RE: REVISED DRAINAGE PLAN FOR DOUG & MARGARET'S HEALTH GYM (H17-D65)
REVISION DATED 4/13/93.

RE: ENGINEER CERTIFICATION FOR DOUG & MARGARET'S HEALTH GYM (H17-D65)
CERTIFICATION STATEMENT DATED 6/16/93.

GRADING & DRAINAGE PLAN
DOUG & MARGARET'S HEALTH GYM
(A.K.A. LIBERTY GYM)

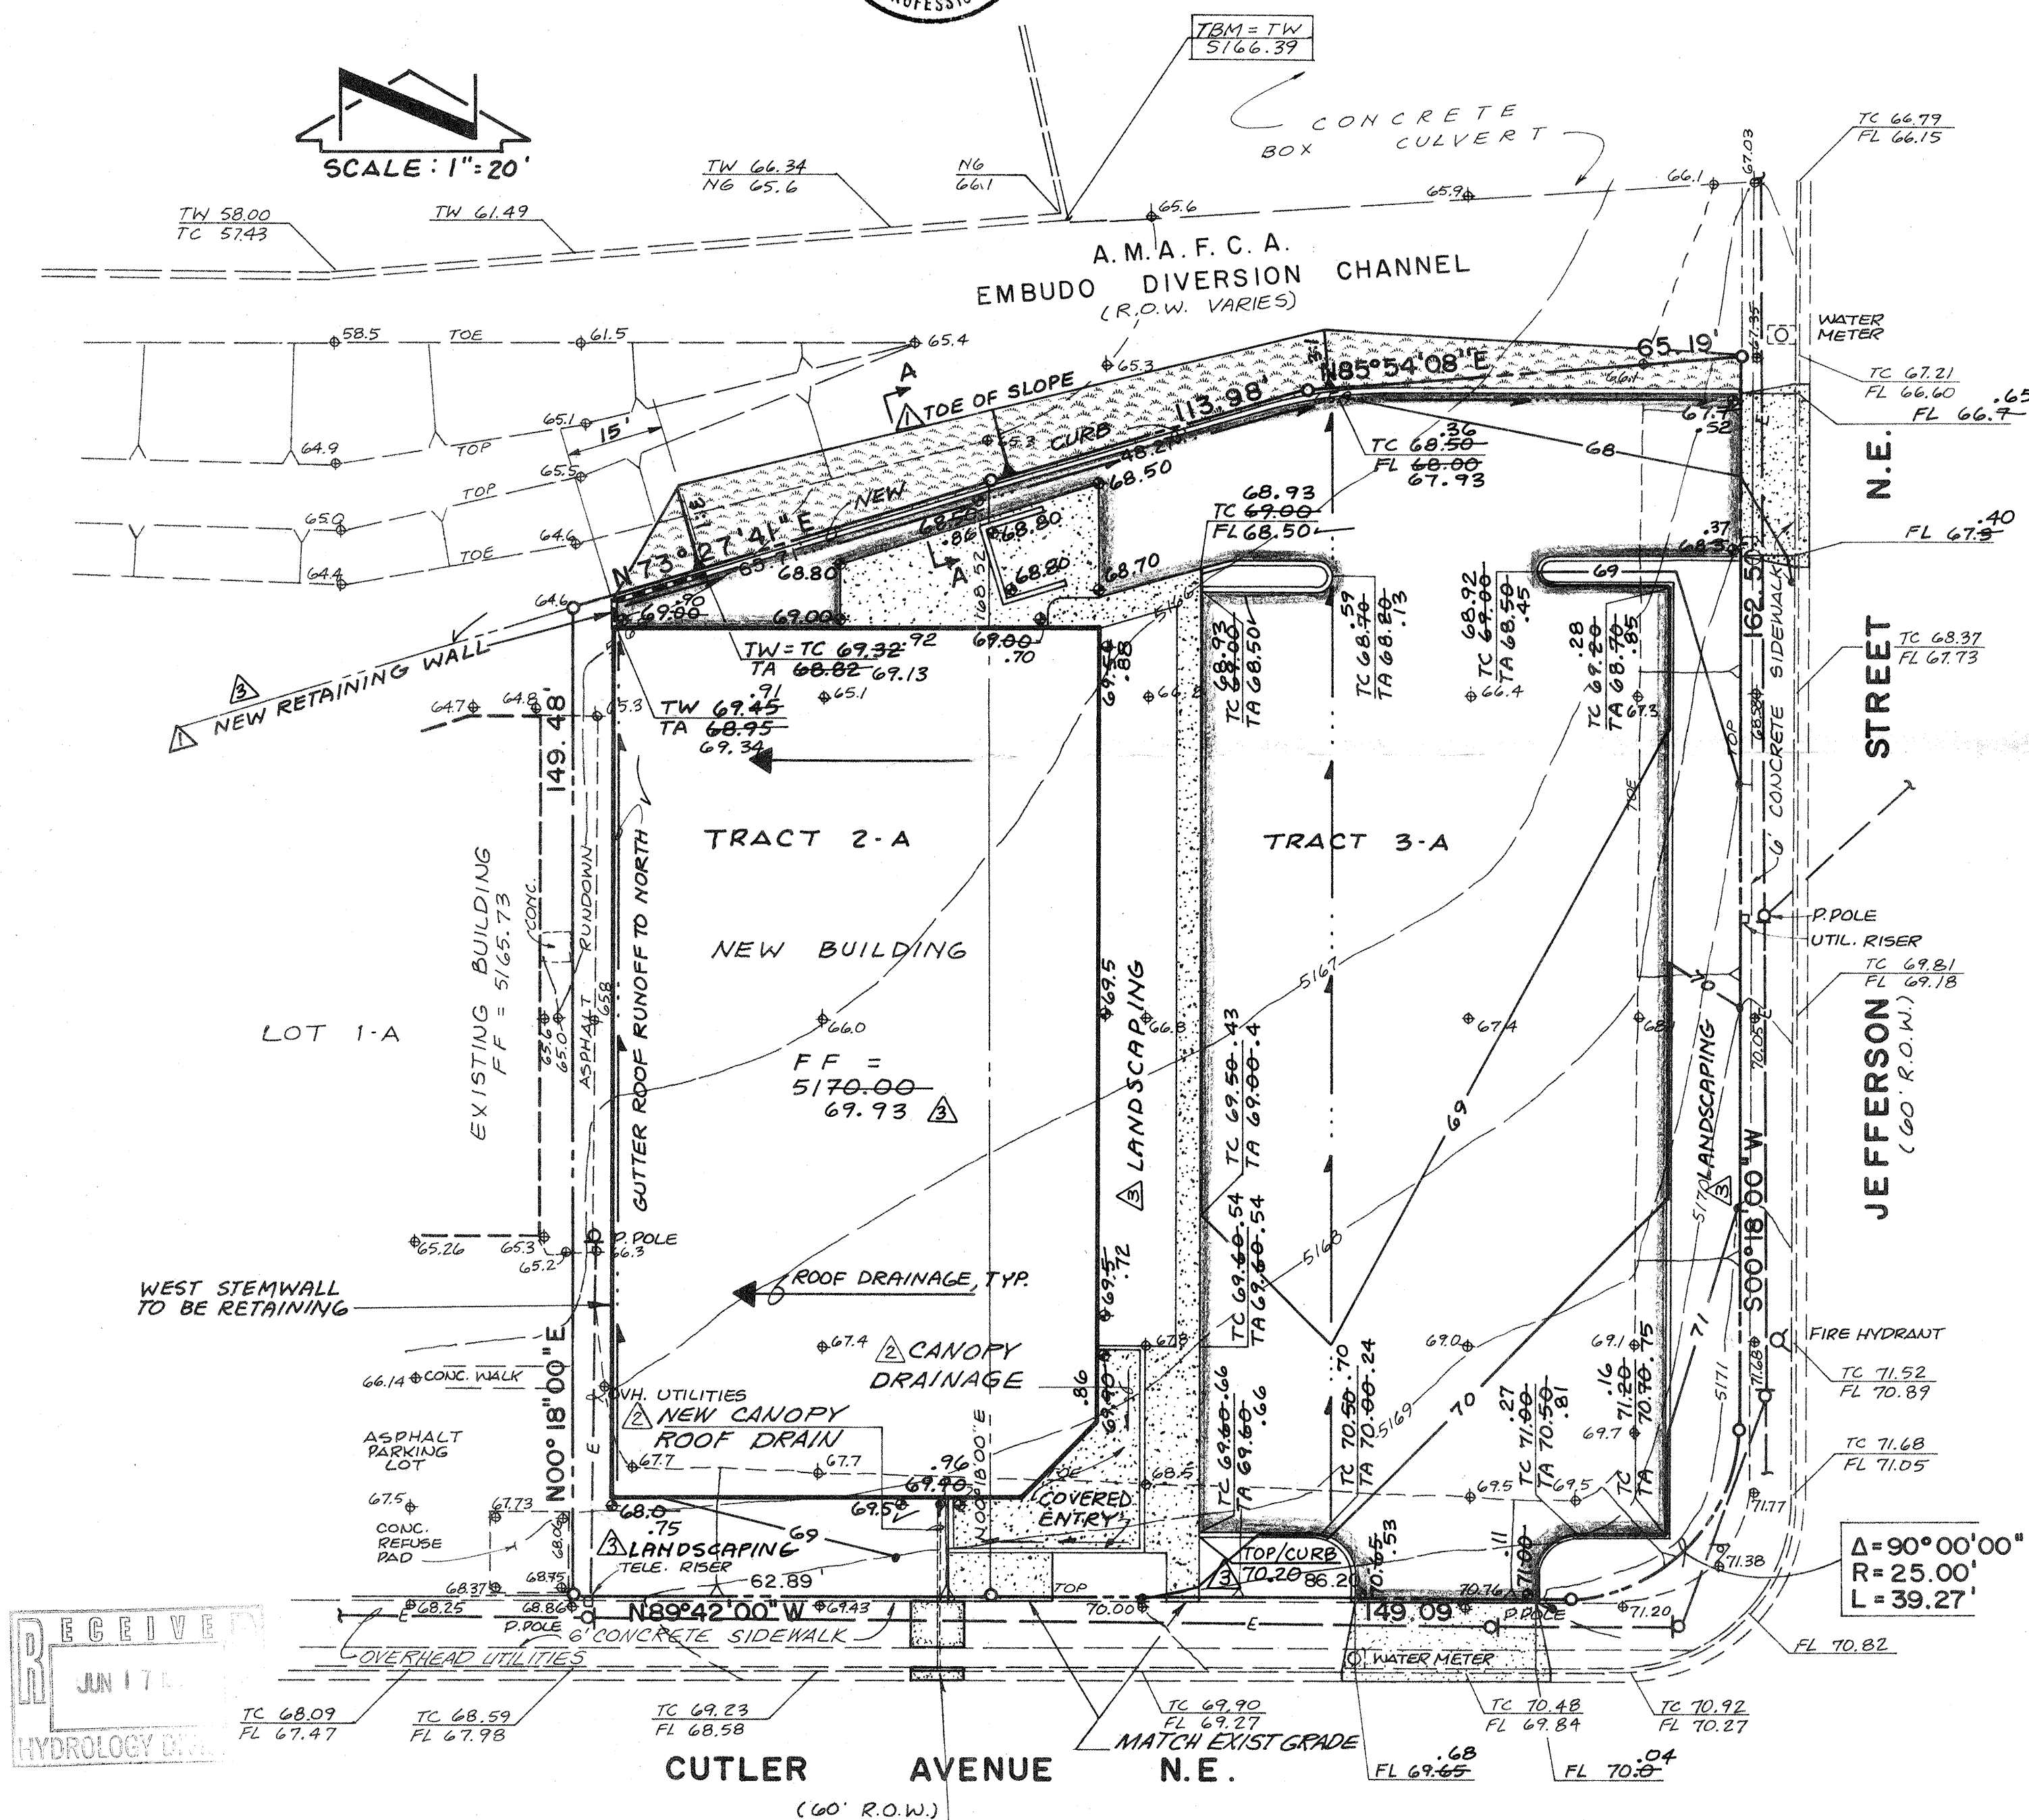
Based on the information provided on your April 13, 1993 resubmittal, the above referenced site is approved for S.O. 19.

Also, prior to Certificate of Occupancy release, the following will be required.

1. concurrence from AMAFCA for grading within their Right-of-Way.
2. Engineer Certification per the D.P.M. checklist.

Please be advised that the Certificate of Occupancy will not be released until
the following approvals are provided:

1. Concurrence from AMAFCA that the work performed within their
Right-of-Way is acceptable.
2. Concurrence from Street Maintenance that the S.O. 19 has been
inspected and accepted.
